Amendments to approved Plan No 0298/12/88/1
18.6.91

Proposed Additions to Res. R W Orator at Lot 1875 of Lot 15 of 1556

13 Roehampton Way Durban North

Engineer: R.W. Orator
Fr. Eng. 8203323
Date: 7.7.88
By: R. Orator
DRG 000-51c

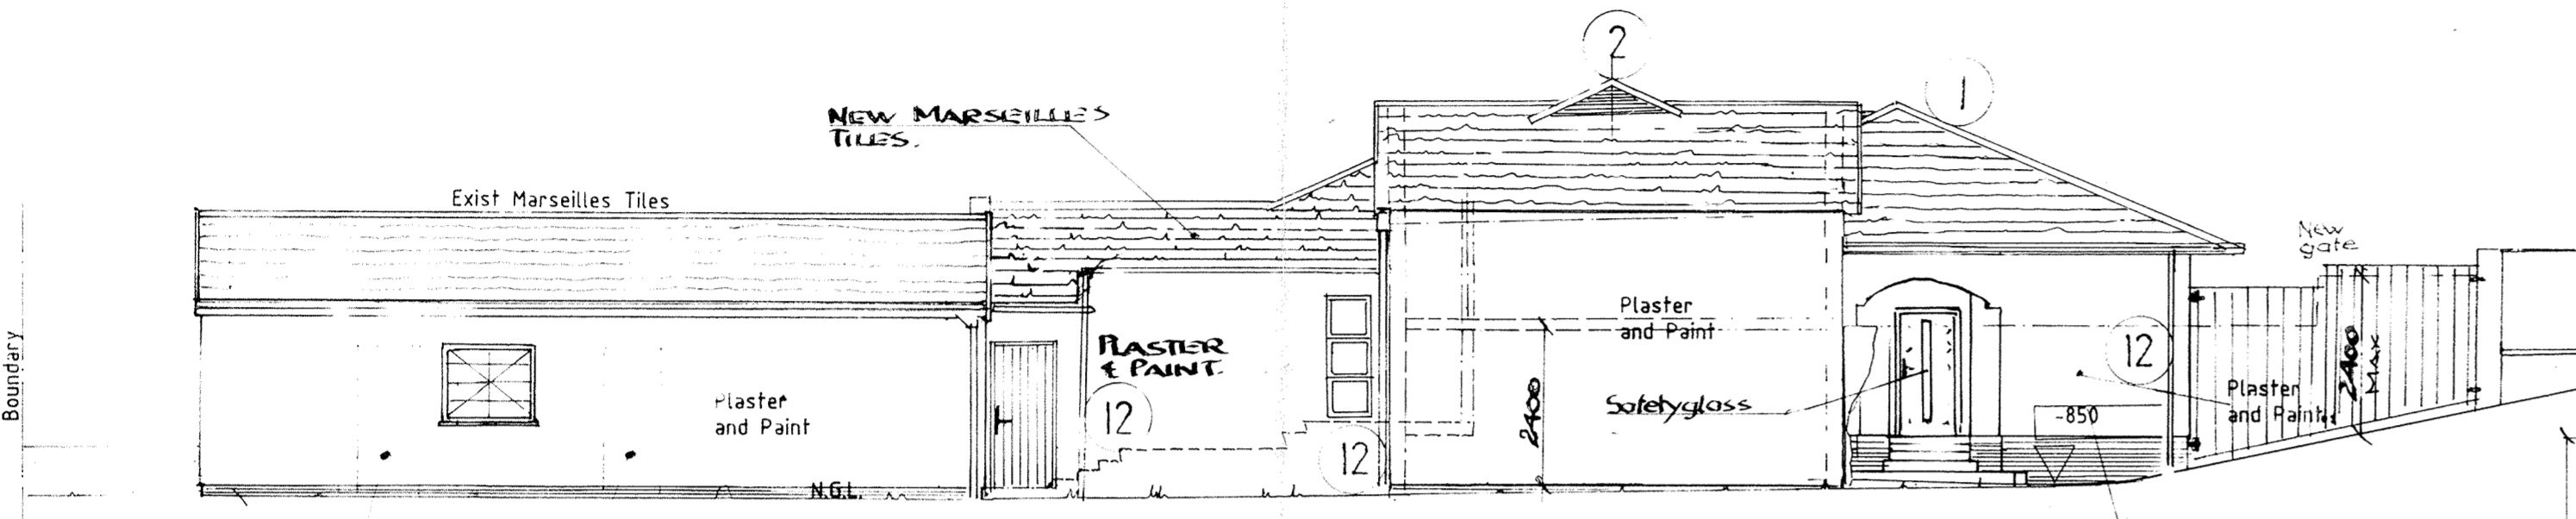
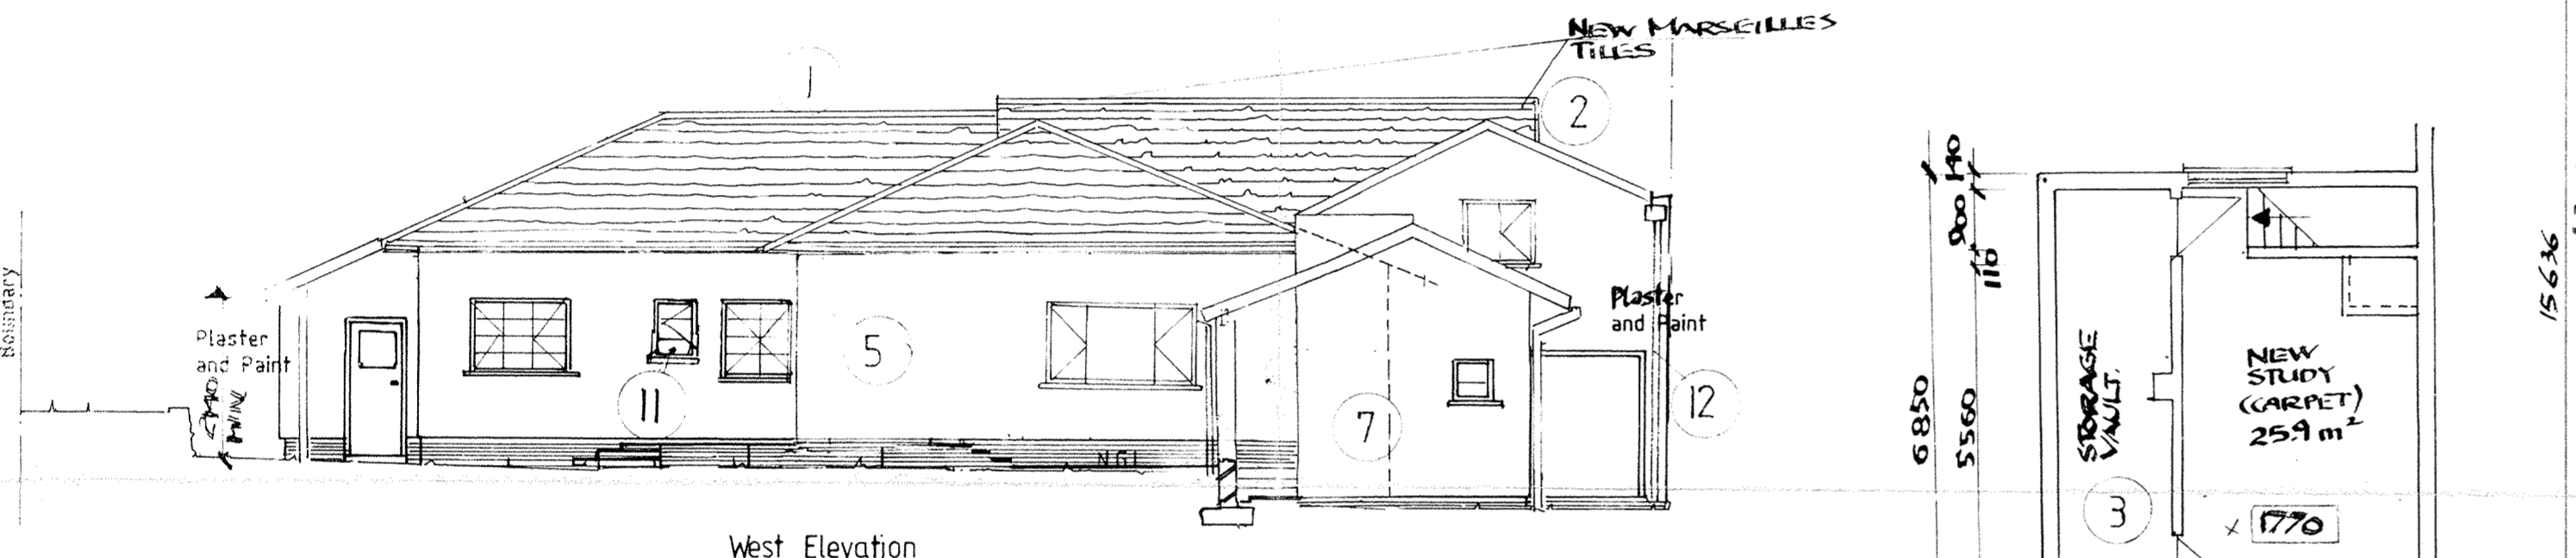
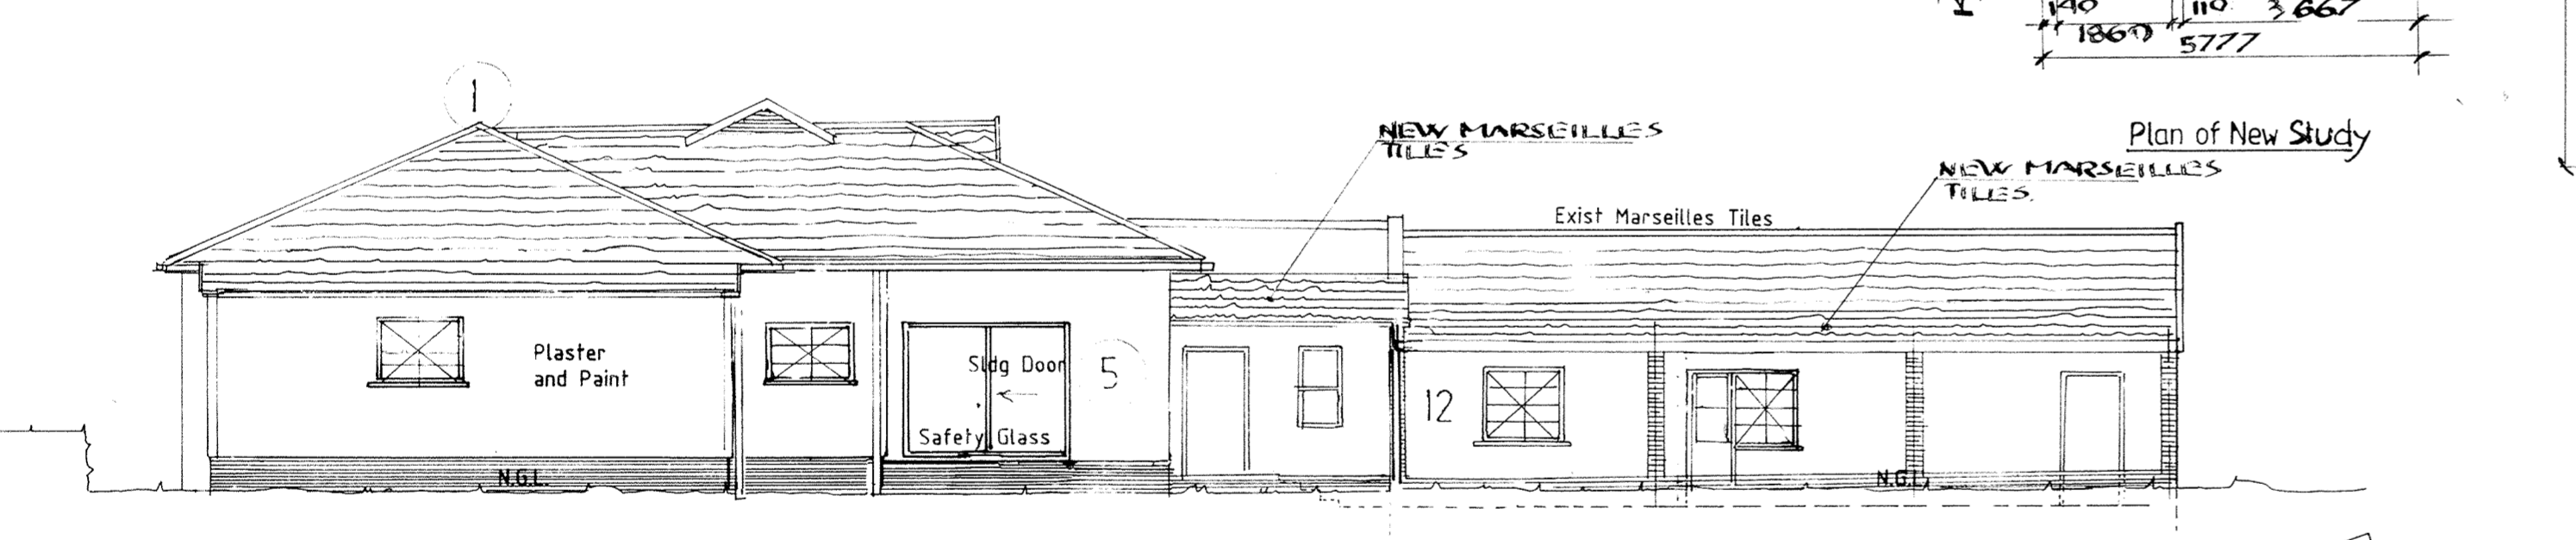
- Amendments**
- The following amendements were made to the approved plan:
- (1) The existing roof was incorrectly shown as having 30 degrees. This has now been amended to the actual 22.5 degrees.
 - (2) Roofline over new studv slightly altered.
 - (3) Storage vault added to first floor.
 - (4) Entrance from garage to house added using solid timber door.
 - (5) Triangular patio in front of lounge removed and made part of lounge.
 - (6) Main building and outbuilding connected and exist poolroom increased.
 - (7) Covered walkway added to outbuilding.
 - (8) Front boundary wall changed from precast concrete to plastered brickwork.
 - (9) Area next to pool covered over in shadecloth.
 - (10) Wallthicknesses to extensions changed from 220 to 140 mm
 - (11) Existing toilet window was incorrectly shown as 550 square. Now corrected to 900x550.
 - (12) New downpipes now shown.
